Docket No. 52-001

SUBJECT: FINAL REPORT TO DOCUMENT THE DISPOSITION OF THE IIRG COMMENTS
ON THE GE NUCLEAR ENERGY (GE) ADVANCED BOILING WATER REACTOR
(ABWR) INSPECTIONS, TESTS, ANALYSES, AND ACCEPTANCE CRITERIA
(ITAAC)

INDEPENDENT REVIEW GROUP COMMENTS REQUIRING DISPOSITION BY GE

Figure 2.11.2 Makeup Water (Condensate) System

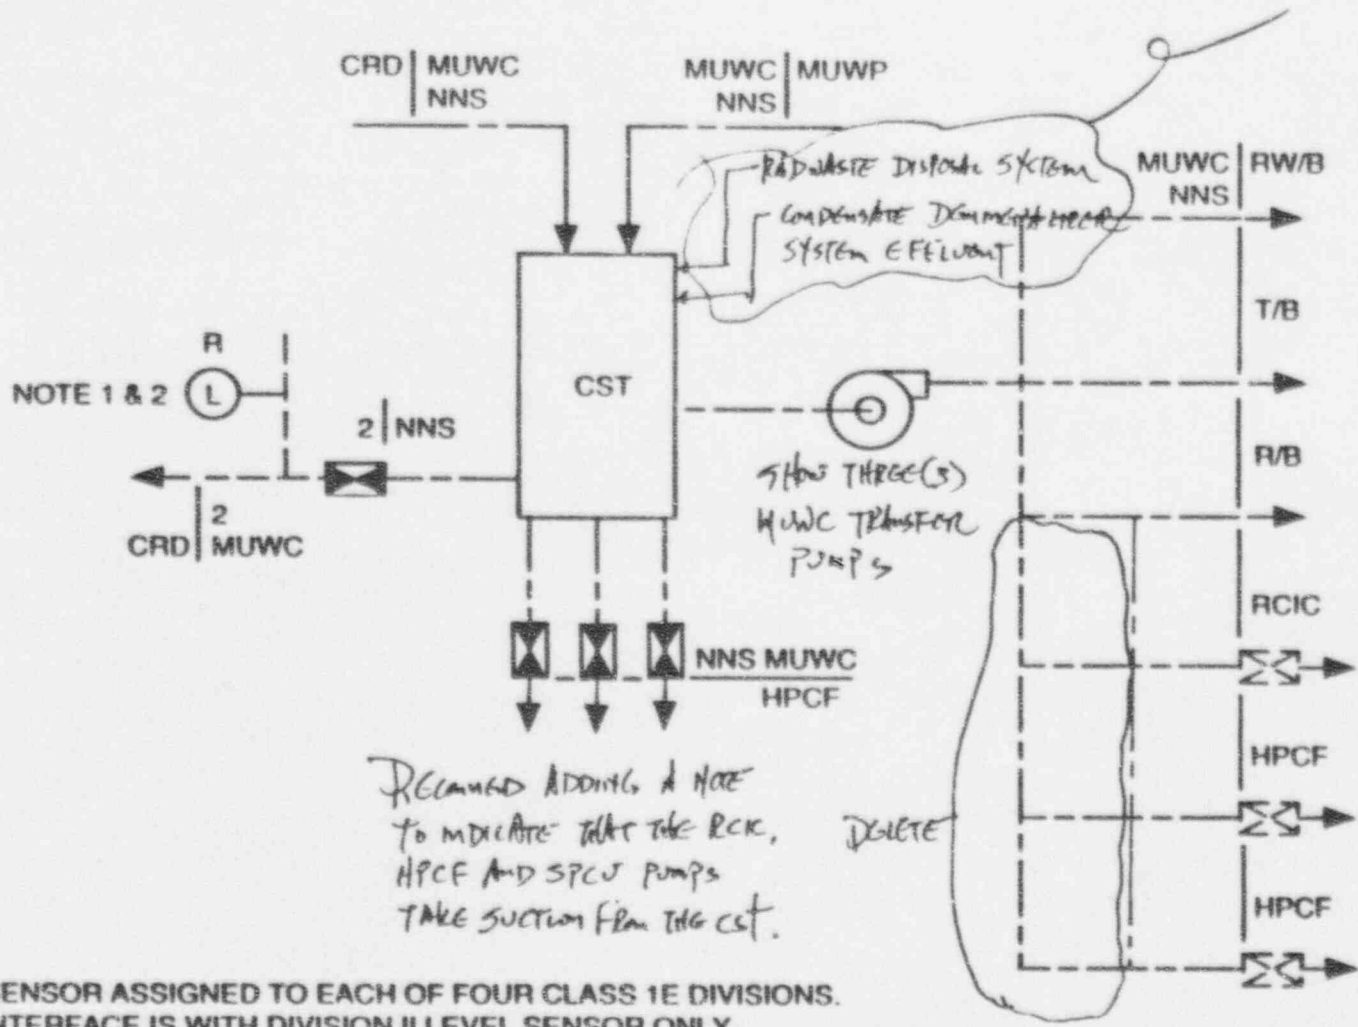
- 3 pumps should be shown, or indicate that this is 1 of 3 pumps.
- A note should be added to figure 2.11.2 to indicate that RCIC, HPCF, and SPCU take suction from the CST.
- The extraneous piping shown on figure 2.11.2 should be deleted.

GE agreed to make the changes.

Figure 2.12.1 Class 1E Electrical Power Distribution System

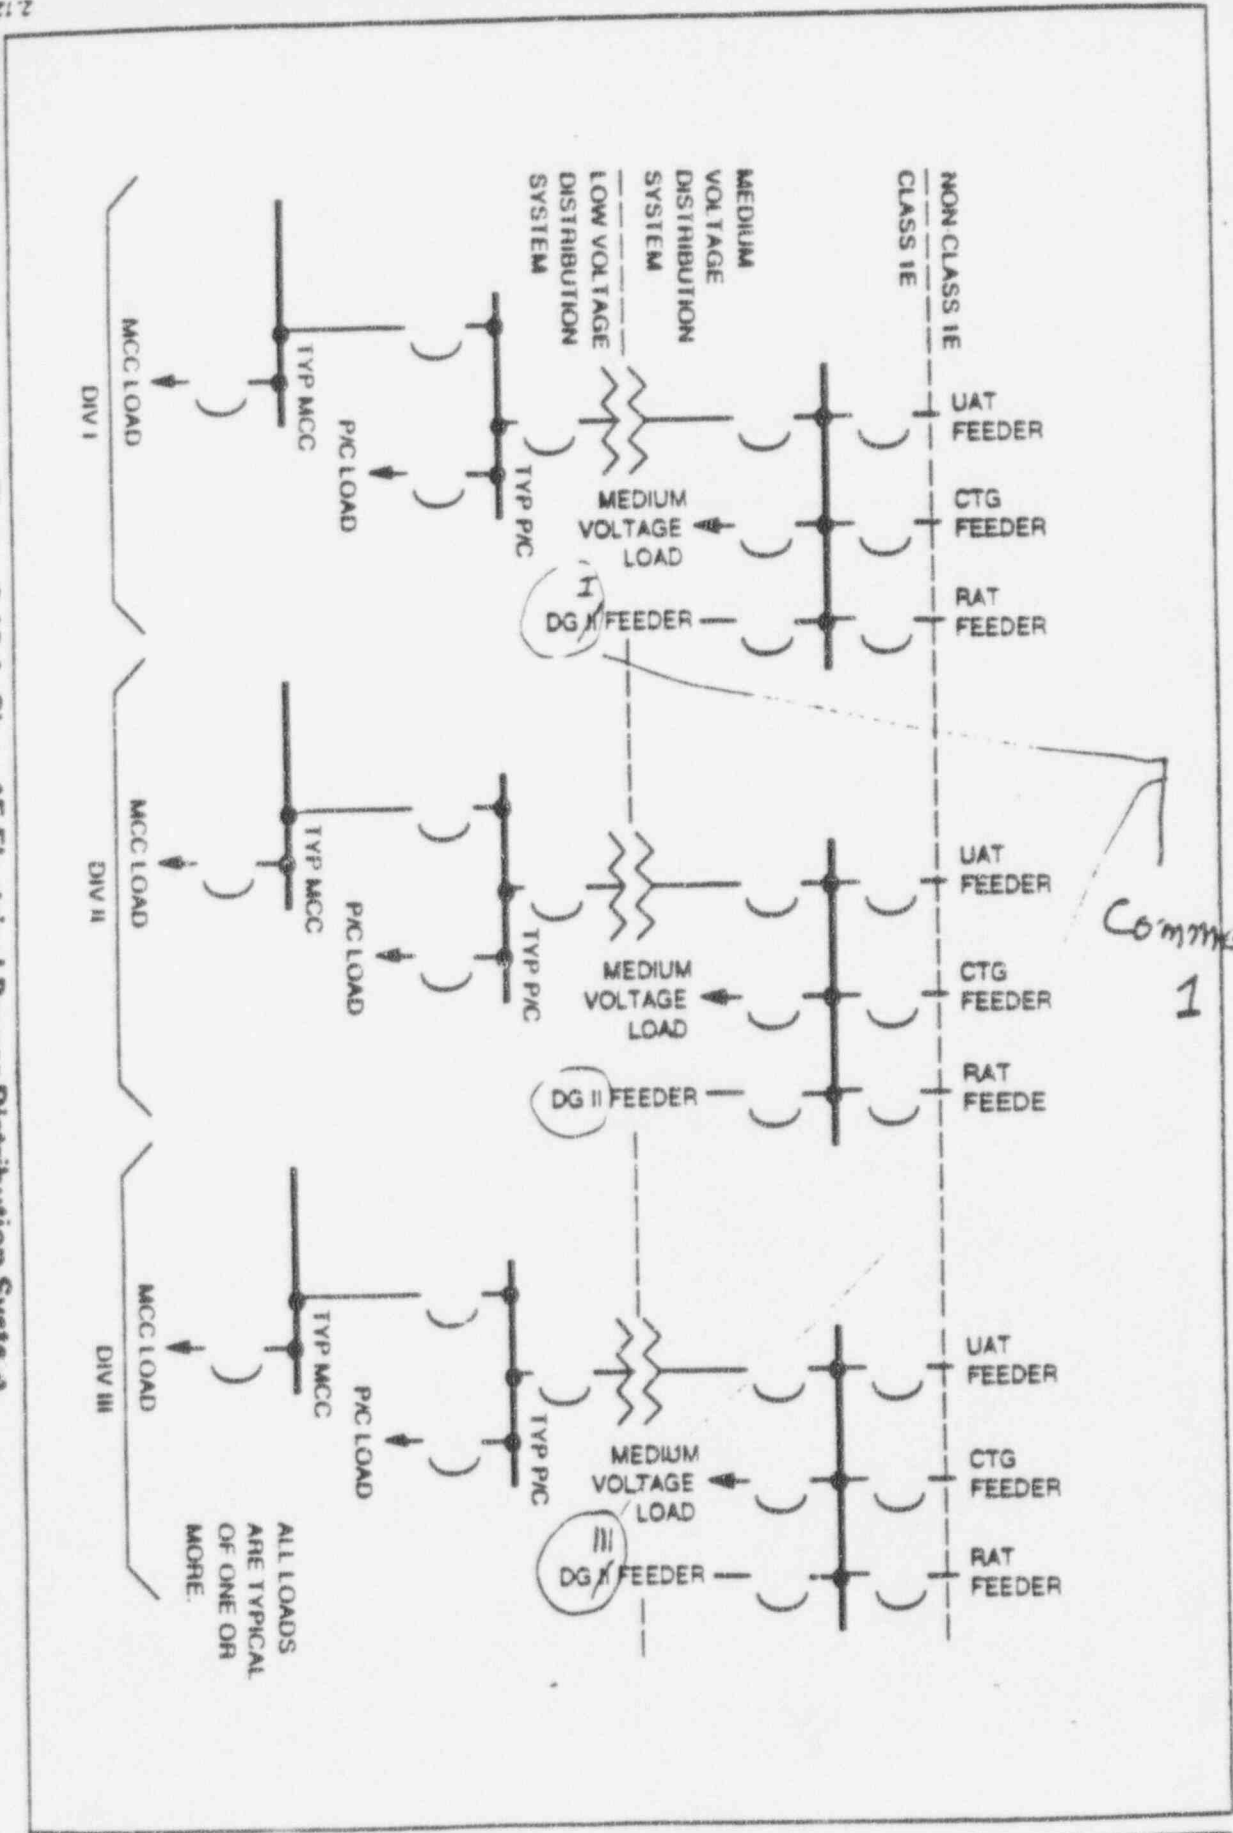
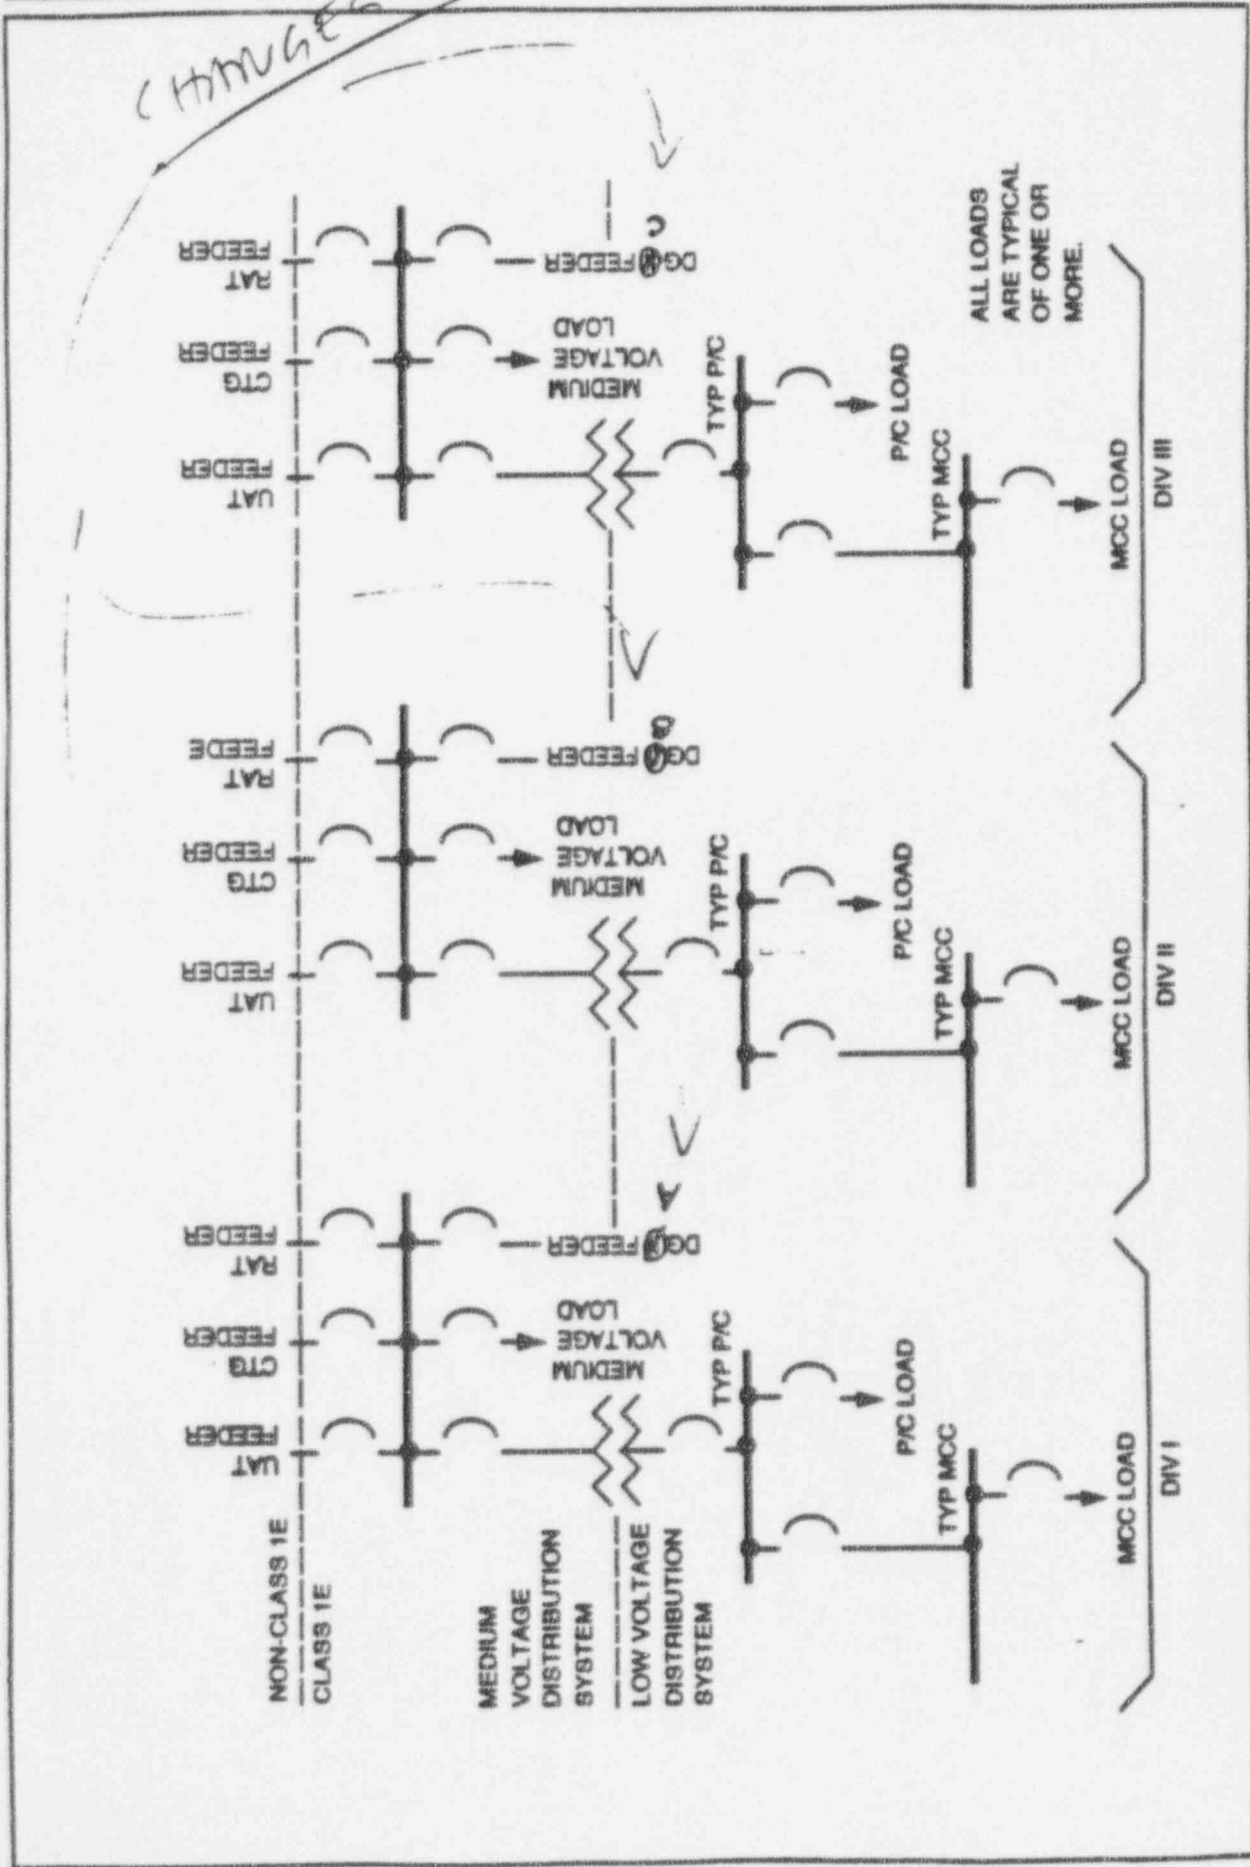
Figure 2.12.1 shows "DG II" feeders for all divisions. It should be changed to "DG I, DG II, and DG III" as shown in attached markup.

GE agreed to make the changes.

Figure 2.14.6 Atmospheric Control System

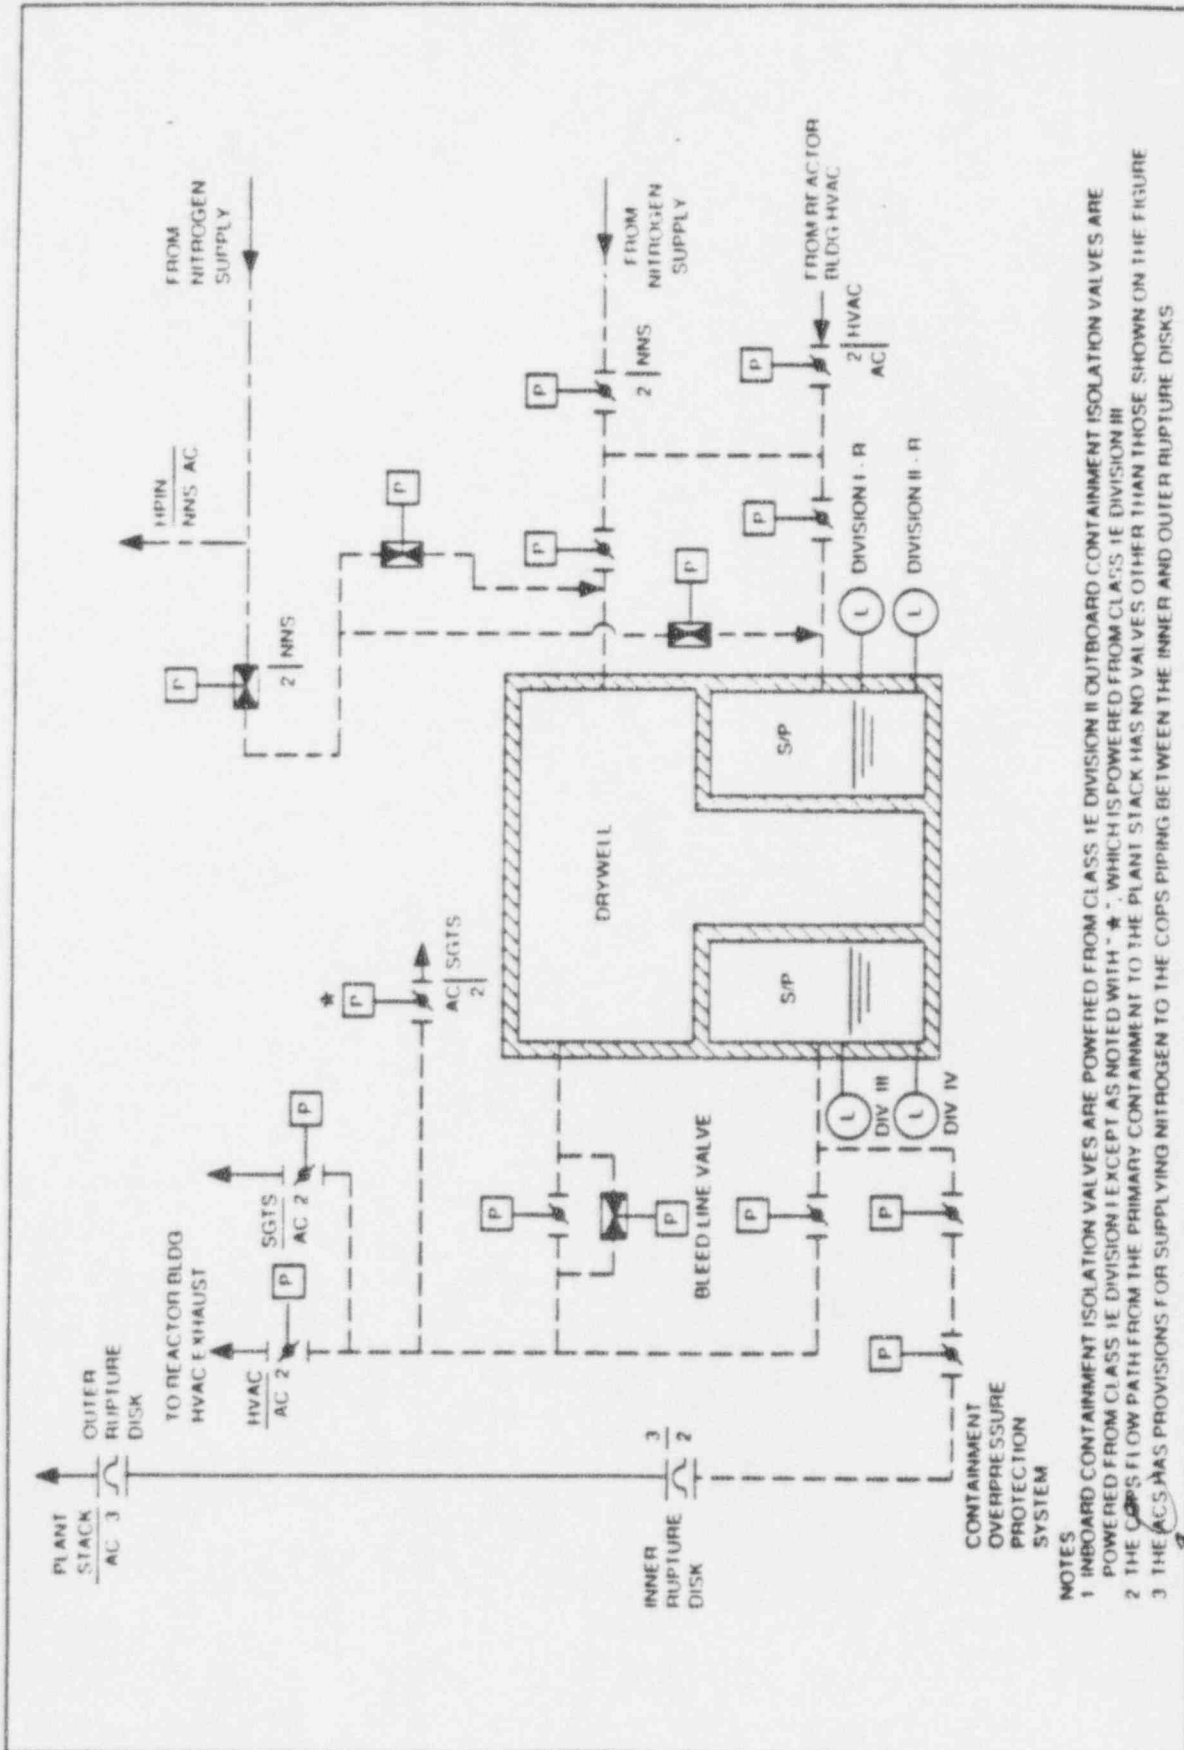
See comments on attached Figure 2.14.6.

- a) valves T31-F32A/B and T31-F734A/D are listed as gate valves and are equipped with solenoid/electric operators. P&ID 6.2-39, Sheet 3 of 3 showed these as manually operated globe valves.
- b) valves T31-F737A-D implies 4 valves whereas on P&ID, only valves A & B are shown.

GE agreed to provide clarification in the SSAR.

Figure 2.15.5a Control Room Habitability Area HVAC System

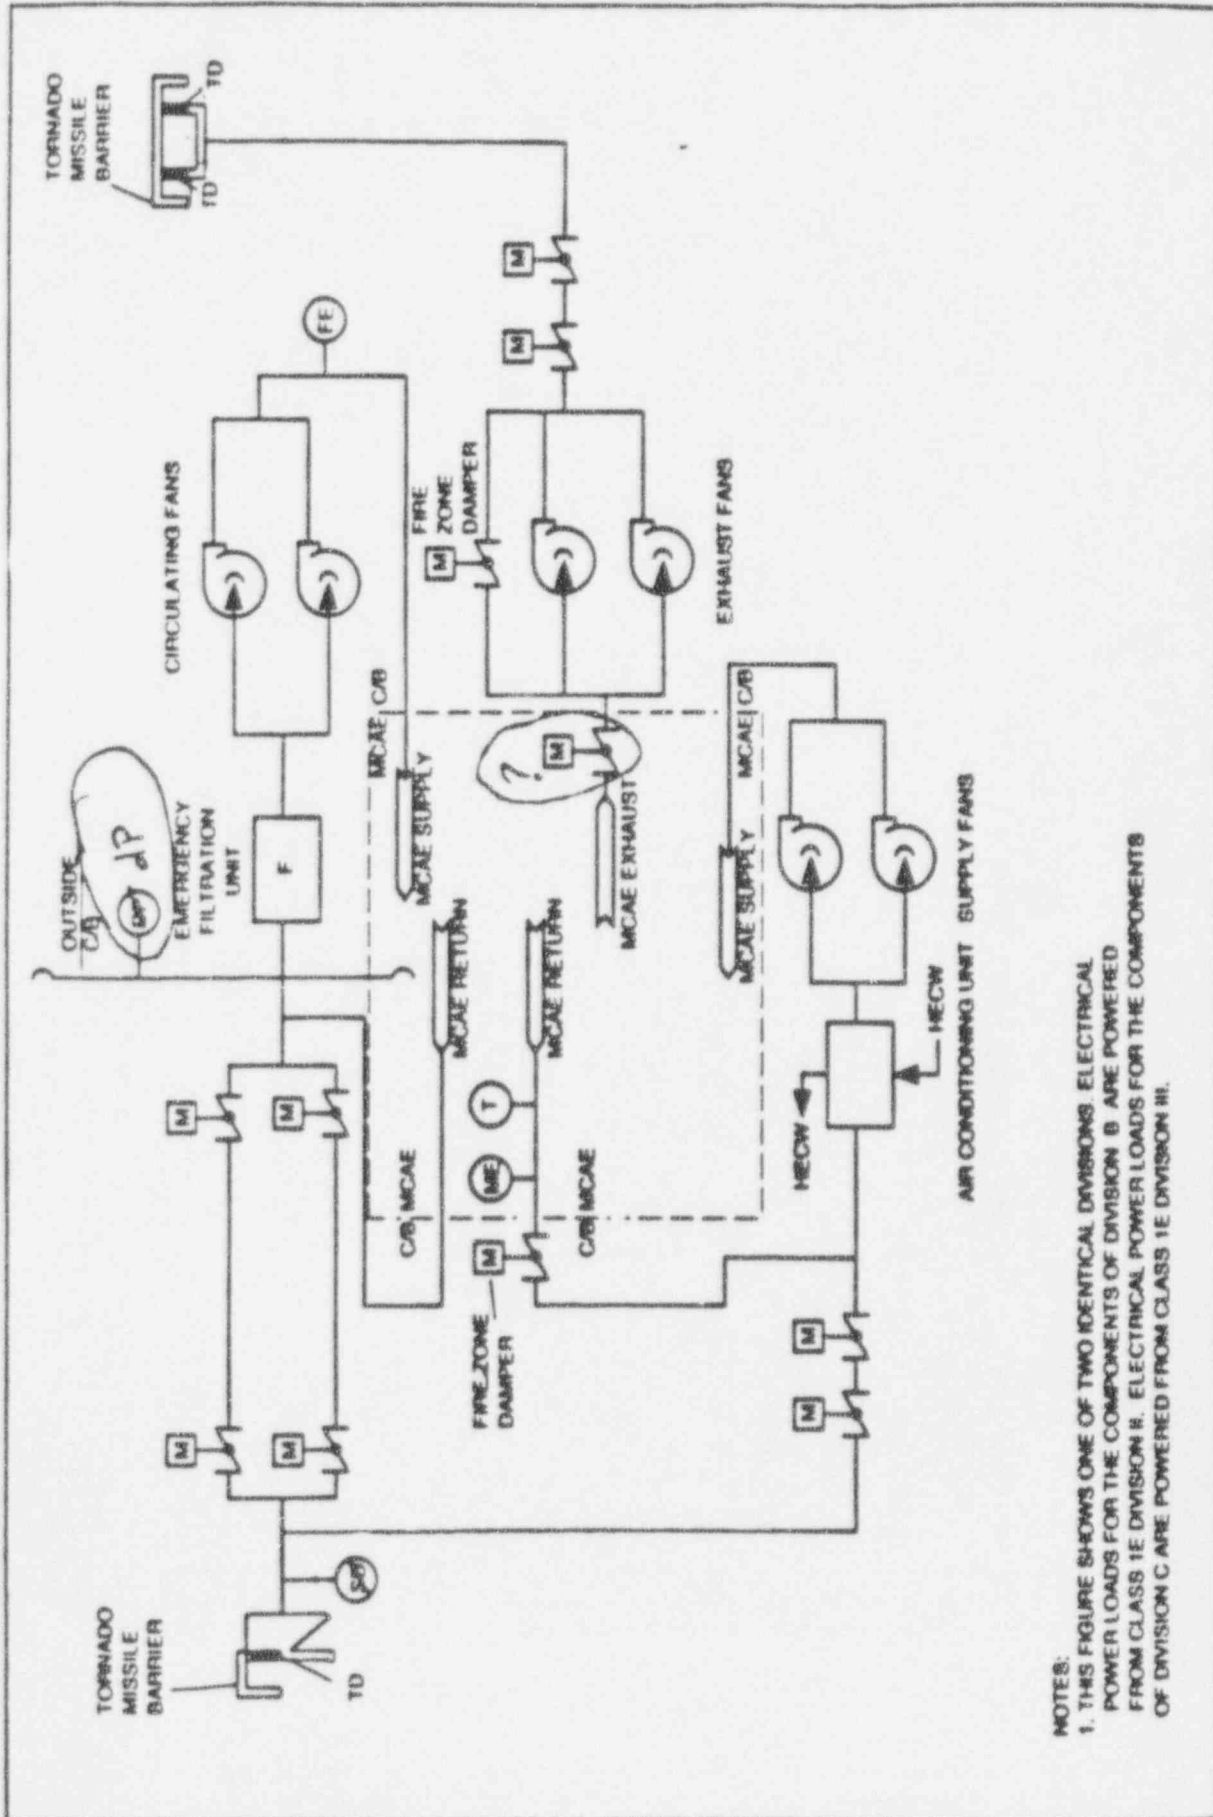
Figure 2.15.5a has an instrument as DP and should be dP and an additional valve on the MCAE exhaust as shown on attached sheet.

(Task Group:) Revise ITAAC figure 2.15-5b to state "dP" not "DP" for differential instrumentation. SSAR Figure 9.4-1 shows "M.O. F012" for each division. No change to ITAAC Figure 2.15.5a is needed.
